FINAL ENVIRONMENTAL IMPACT REPORT

This FEIR contains comments and responses to comments received on the draft environmental impact report (DEIR) for the Coyote Creek Agrivoltaic Ranch Project, along with the entire body of the DEIR showing revisions to the DEIR made in response to comments. See Chapter 20 for comments and responses to comments.

REDUCED FOOTPRINT PROJECT AS STAFF RECOMMENDED PROJECT

Plate PF-1: Reduced Solar Development Area

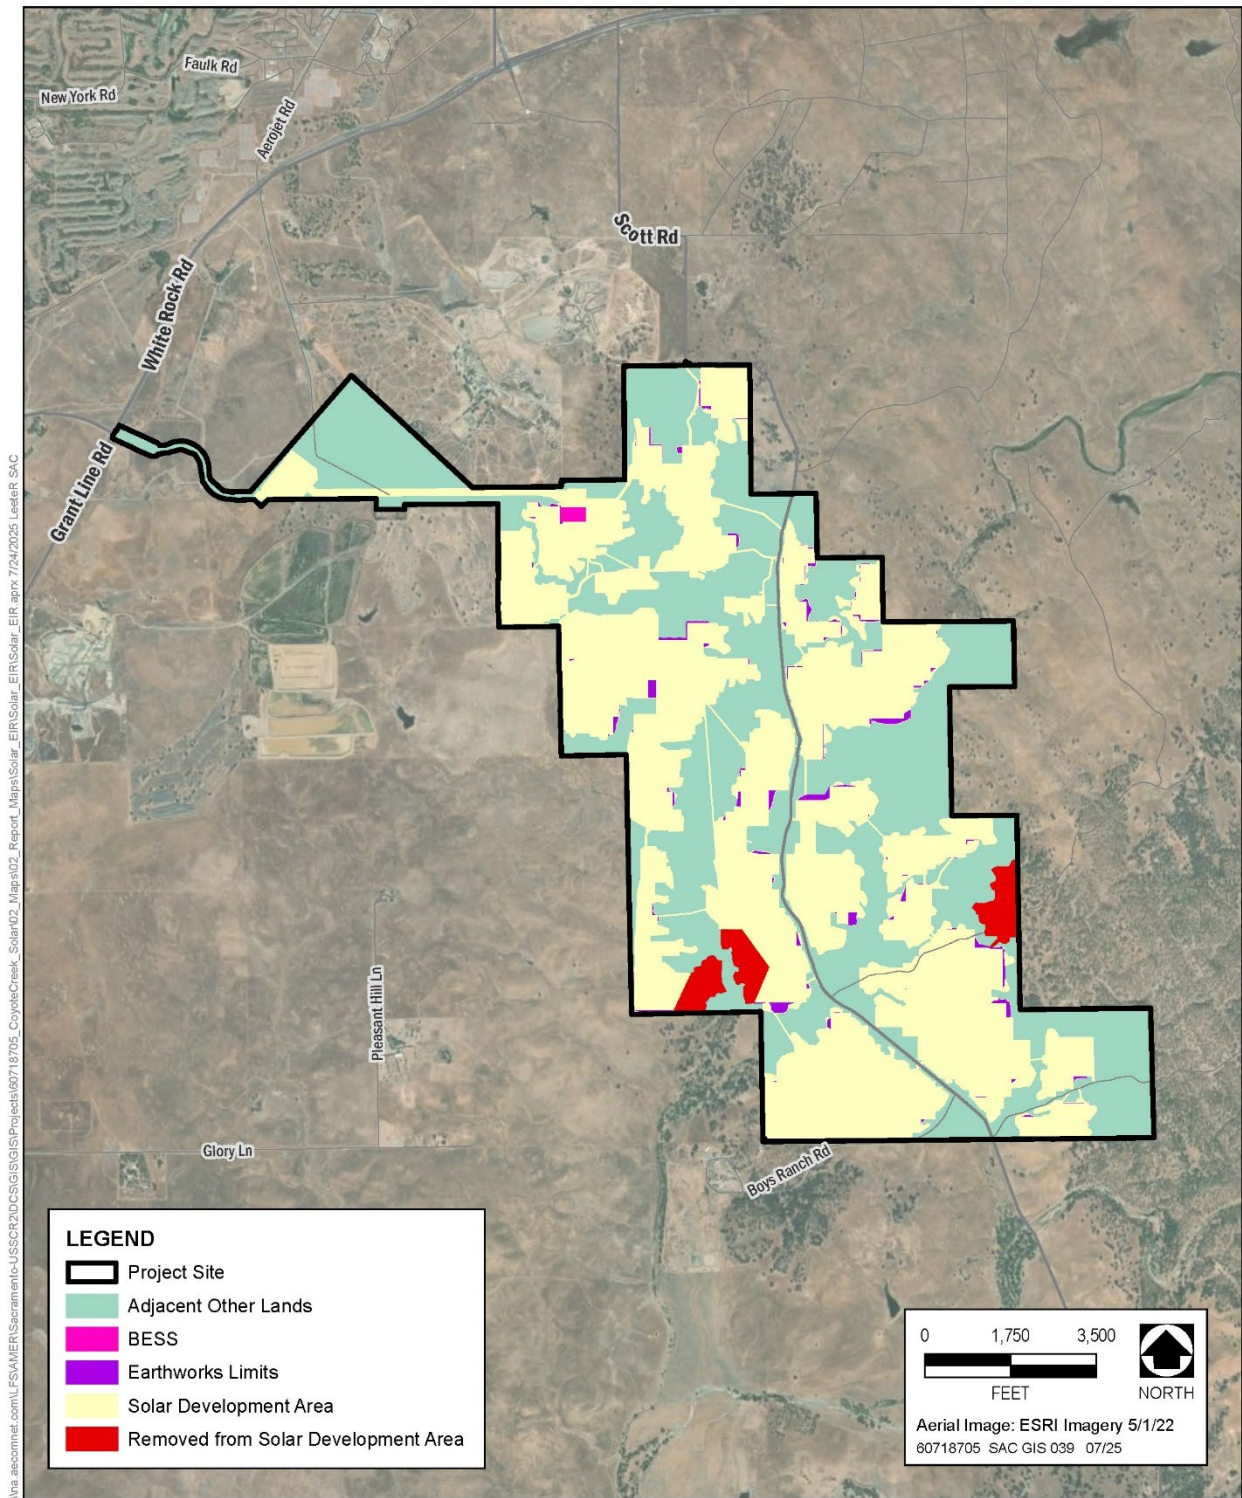
Both the original proposed project contemplated in the DEIR and the Reduced Footprint Project would construct and operate a 200-megawatt (MW) solar photovoltaic energy-generating facility for a period of approximately 35 years. Compared with the original proposed project, the Reduced Footprint Project would remove 55 acres from the solar development area in the southern portion of the project site to increase preservation of oak woodlands and habitat for special-status wildlife species. The area to be removed from the solar development area is shown in Plate PF-1. Since the original proposed project in 2021, modest gains in technology have allowed for improvements in panel wattages that can be procured. Thus, the project can reduce its footprint while maintaining the same overall capacity.

The reduction in solar development area embodied in the Reduced Footprint Project would reduce the impact to blue oak forest by 26.2 acres (26 percent), would reduce the impact to blue oak woodland by 18.5 acres (10 percent), and would reduce the impact to riparian forest by 1.1 acres (26 percent). The impact to valley and foothill grassland would be reduced by 9.2 acres (approximately 1 percent).

Compared to the original proposed project, the Reduced Footprint Project would also reduce the impacts to individual trees and oak canopy cover. The Reduced Footprint Project would avoid impacting 1,294 individual trees (27 percent) and would reduce the impact to oak canopy cover by 13.25 acres (24 percent). The reduction in solar development area under the Reduced Footprint Project would also reduce grading and blasting-related impacts. With the Reduced Footprint Project, approximately 27.9 acres that would have required grading or blasting would no longer require grading or blasting to prepare the site for installation of the solar arrays and ancillary improvements. Reductions in grading and blasting activities would in turn reduce air pollutant emissions
